MELIADINE WEST GOLD PROJECT

WASTE ROCK and ORE STORAGE MANAGEMENT PLAN for MATERIALS GENERATED DURING THE EXCAVATION OF THE EXPLORATION DECLINE at the TIRIGANIAQ DEPOSIT, MELIADINE WEST PROJECT

Addendum 1

April 2009

Figure 1

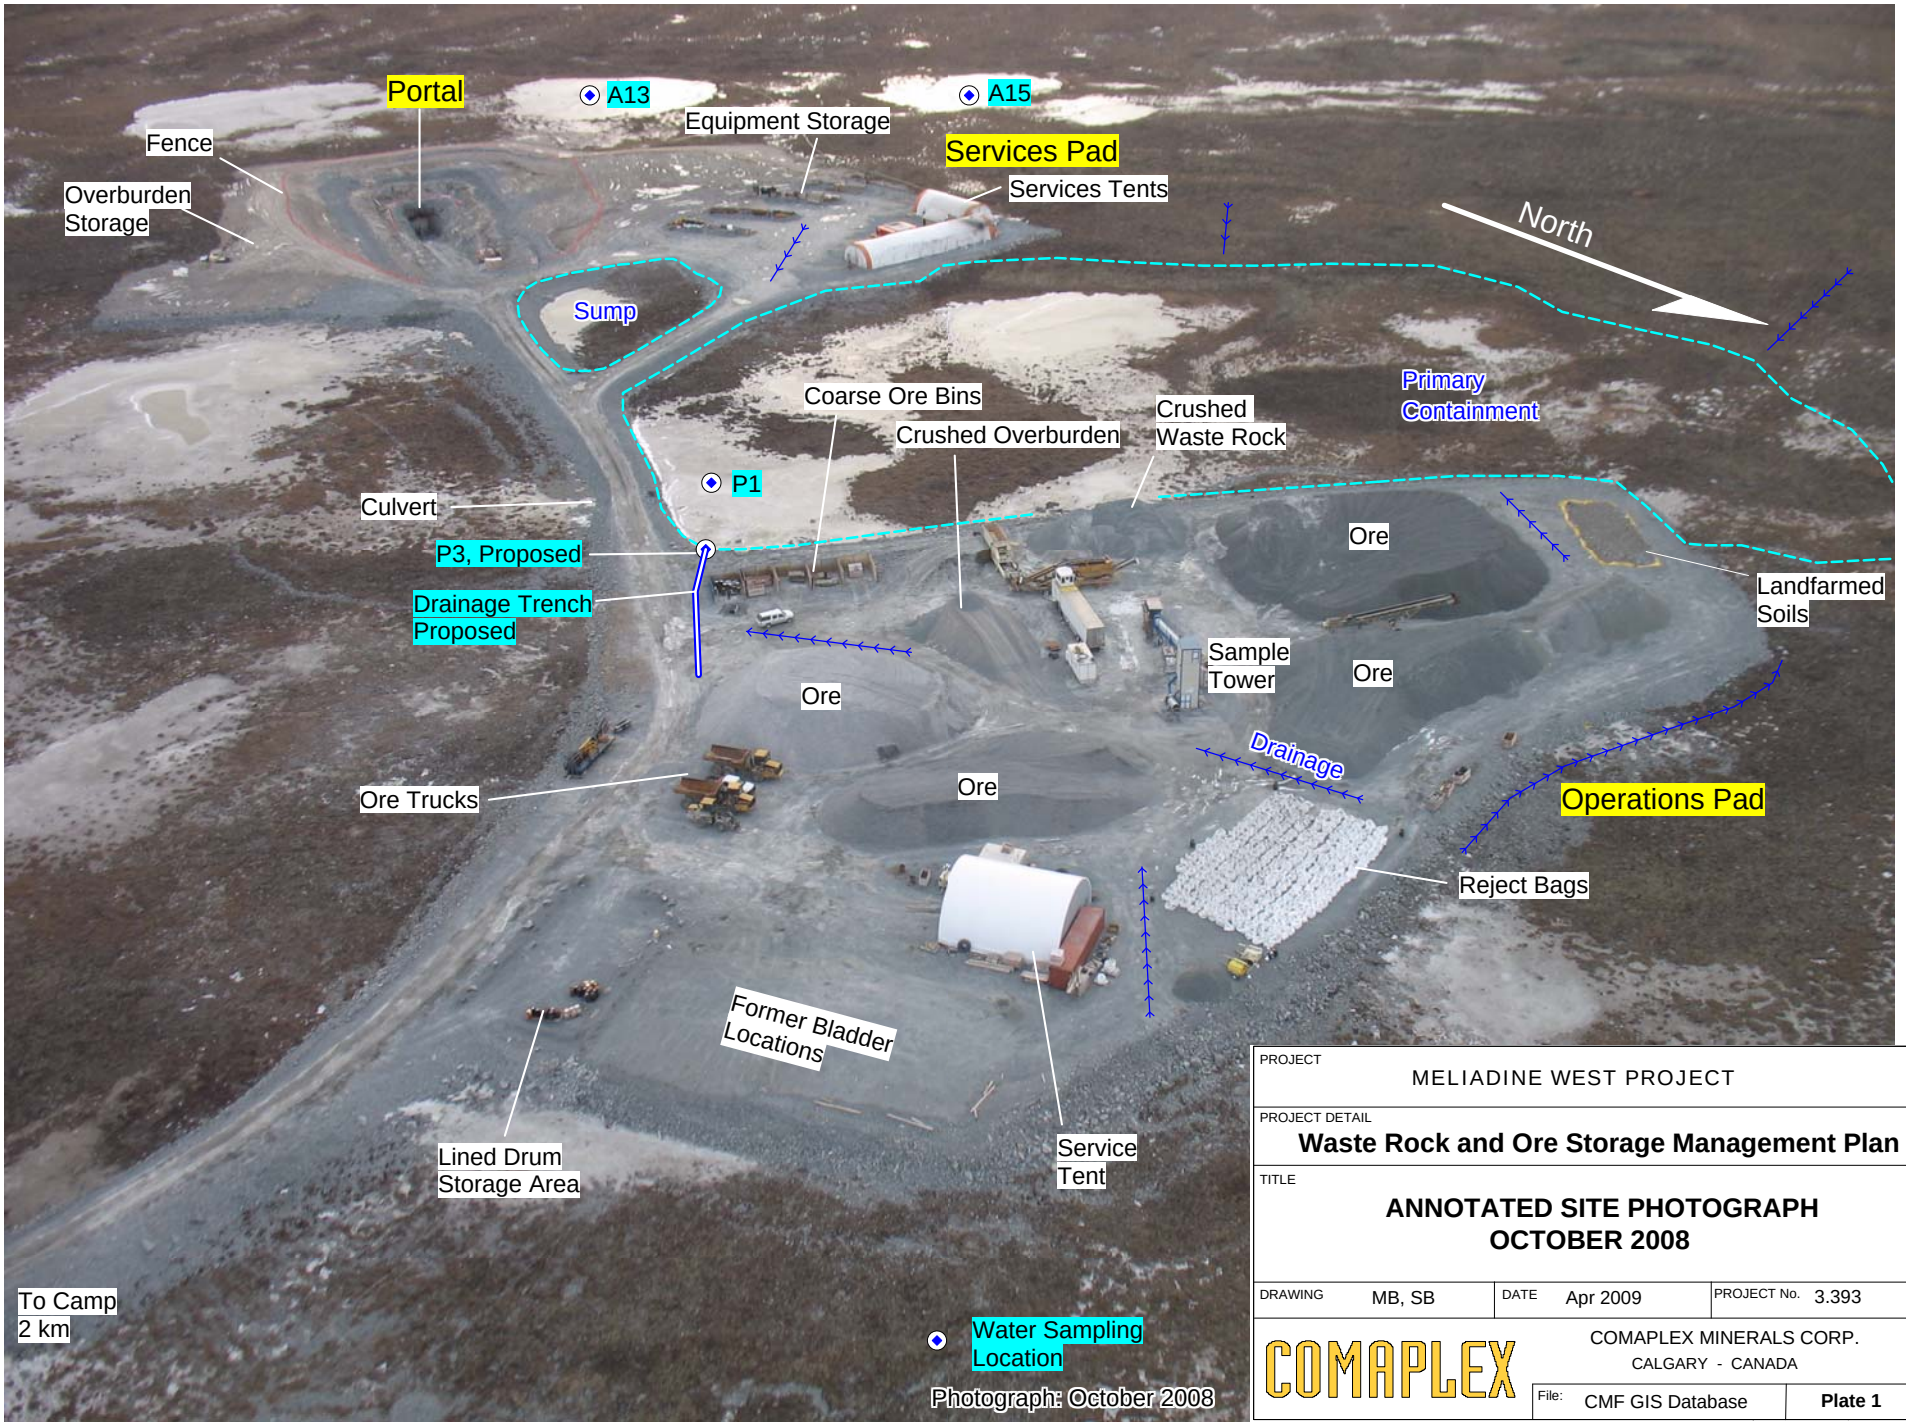
The objectives of this addendum are to respond to questions posed by the Nunavut Water Board (NWB) in their letter dated January 14, 2009. The questions are paraphrased below:

Figures 1 and 2 illustrate the drainage patterns of the site and monitoring stations both mandated by the NWB and initiated independently by Comaplex Minerals Corp. The KIA, in a letter dated March 18, 2009, requested that all monitoring sites shown on Figure 1 be sampled monthly to better assess the impacts of the surface infrastructure. Comaplex has agreed to this change in the monitoring plan for the calendar year 2009 and will commence monitoring of available sites, dependent on ice conditions, in late May, 2009 to continue monthly until September 2009, at which time, upon reception and analysis of results obtained in 2009, Comaplex proposes to re-evaluate sampling frequency. There has been no measureable affect from the exploration activities on the receiving water body shown on Figure 1 (Pump Lake).

Comaplex acknowledges the necessity of containing and testing the run-off from the waste rock pads. The containment of runoff is effectively provided by the primary containment area (Figures 1,2, Plate 1). Water sampling at P1 is also affected by other local run-off. Figures 1 and 2 indicate the location of a proposed drainage trench to be installed during the summer of 2009 after spring thaw. The trench will collect surface runoff from the waste rock pads and ore piles and deliver the waters to the primary containment area (P1). An additional water sampling site will be established (P3, Figure 2) at the toe of the pad at the end of the drainage trench where it will be possible to assess the quality of water draining directly off the pad. Sampling at P3 will likely need to be performed opportunistically during periods of sustained rainfall as this location will not be prepared for spring runoff. Testing at P3 will include the full suite of routine, nutrient and metal parameters and will include pH, ammonia, total suspended solids (TSS) and BTEX / TPH hydrocarbons.

Figures 1 and 2 are preliminary as-built drawings showing the final layout of the site after completion of the Bulk Sample Program. A cross – section of the waste rock pads based on ground survey data is given in Figure 3. Additional surveying is required to complete final as-built drawings of the site and will be completed in June of 2009 once the snow melts. Updated detailed as-built plans, including cross-sections, stamped by a Nunavut registered engineer, will be forwarded to your office when the surveying is complete.
